SAFETY EVALUATION
FACILITY OPERATING LICENSE NO. DPR-43
DOMINION ENERGY KEWAUNEE, INC.
KEWAUNEE POWER STATION
DOCKET NOS. 50-305 AND 72-64

1.0 INTRODUCTION

Figure 1
NAC Secure Lift System
and Stack-Up Configuration

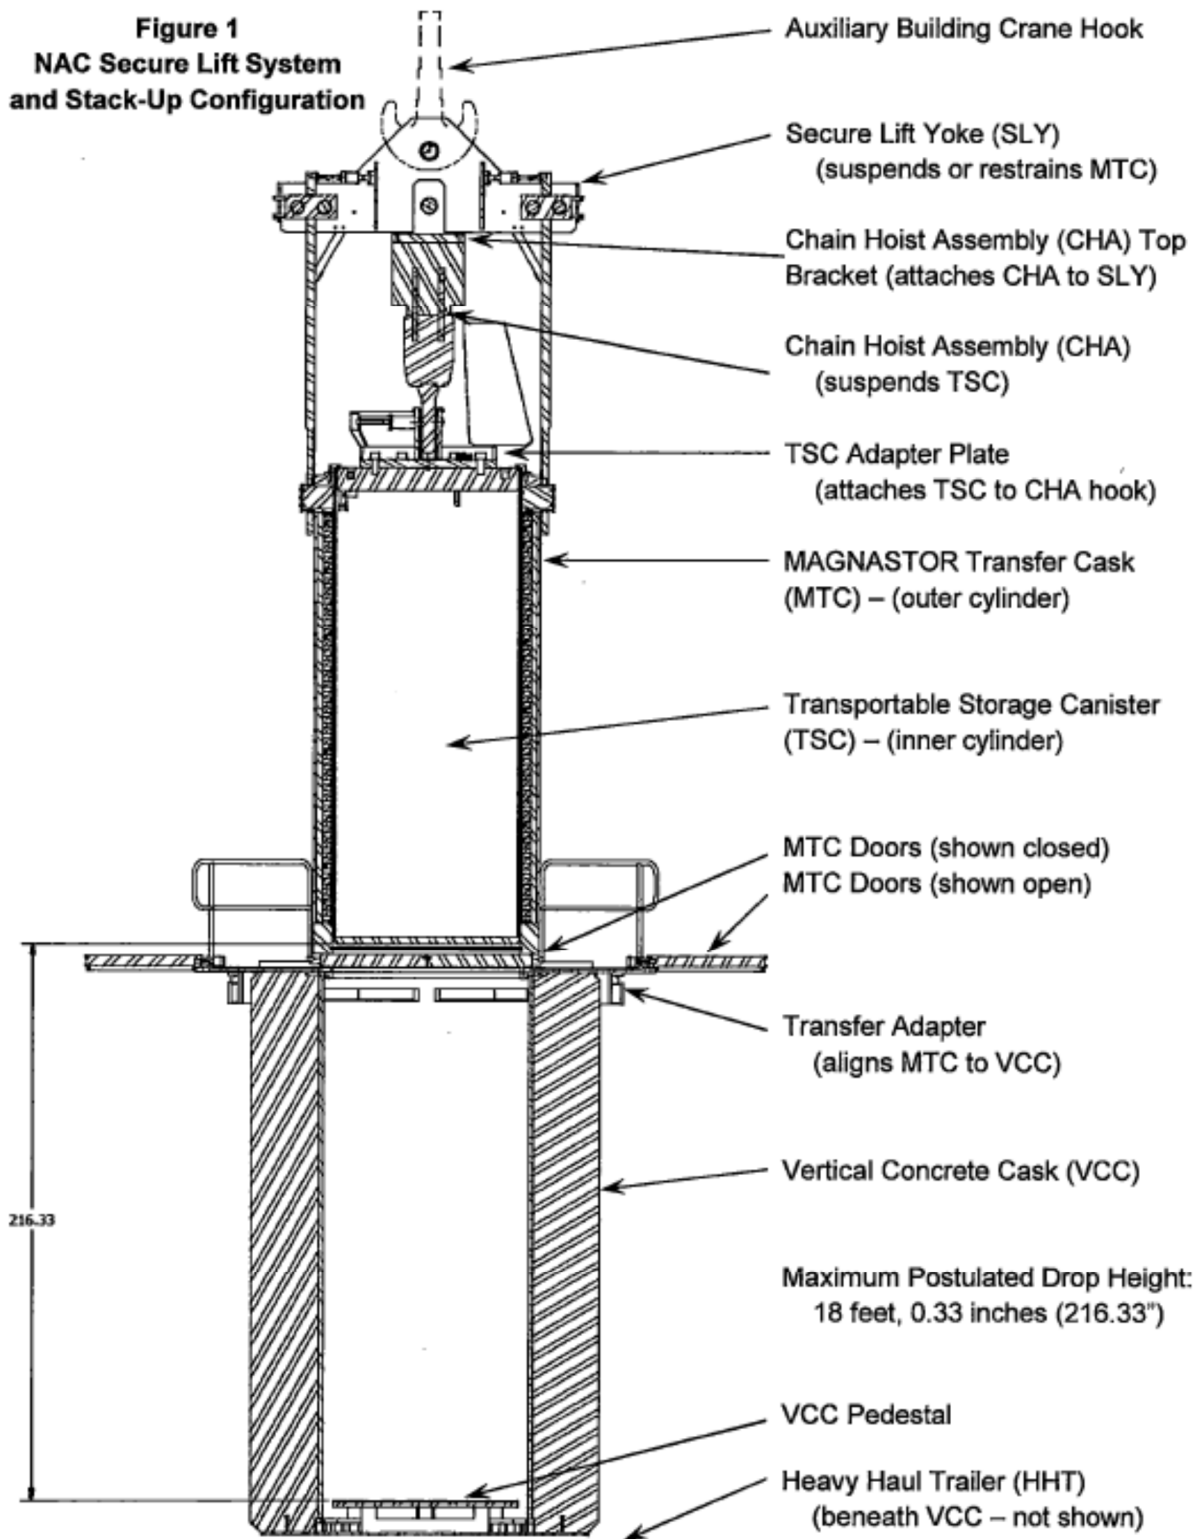
After the entire system is in the stack-up configuration (supported by the auxiliary building crane), the chain hoist assembly is used to lift the TSC off of the MTC doors approximately one-half inch. Following a five minute hold, the MTC doors are opened and the chain hoist assembly is used to lower the TSC into the VCC located on a heavy haul trailer in the truck bay. Once the TSC is in position on the VCC pedestal, the TSC adapter plate is unbolted from the TSC lid and the chain hoist assembly is used to lift the TSC adapter plate into the MTC to permit closure of the MTC shield doors. Throughout this entire operation, the TSC is confined inside the MTC or VCC. Furthermore, the MTC remains connected to the secure lift yoke, which is pinned to the hook of the auxiliary building crane. The chain hoist assembly is used for lowering the TSC from the MTC into the VCC (loading) or raising the TSC into the MTC from the VCC (unloading).

The components described above are shown in the stack-up configuration in Figure 1 provided by DEK below.

Once in the stack up configuration, the chain hoist assembly is connected to the TSC and the chain hoist assembly is used to lift the TSC off the MTC doors. The chain hoist assembly is not consistent with guidelines of Section 5.1.6 of NUREG-0612 as a single-failure-proof hoisting device. Consequently, a failure of the hoist is considered a credible accident condition. To ensure an acceptable level of defense-in-depth consistent with NUREG-0612 guidelines, the licensee chose to evaluate the consequences of a postulated drop of the loaded TSC from the highest lift height while attached to the chain hoist assembly to the VCC pedestal.
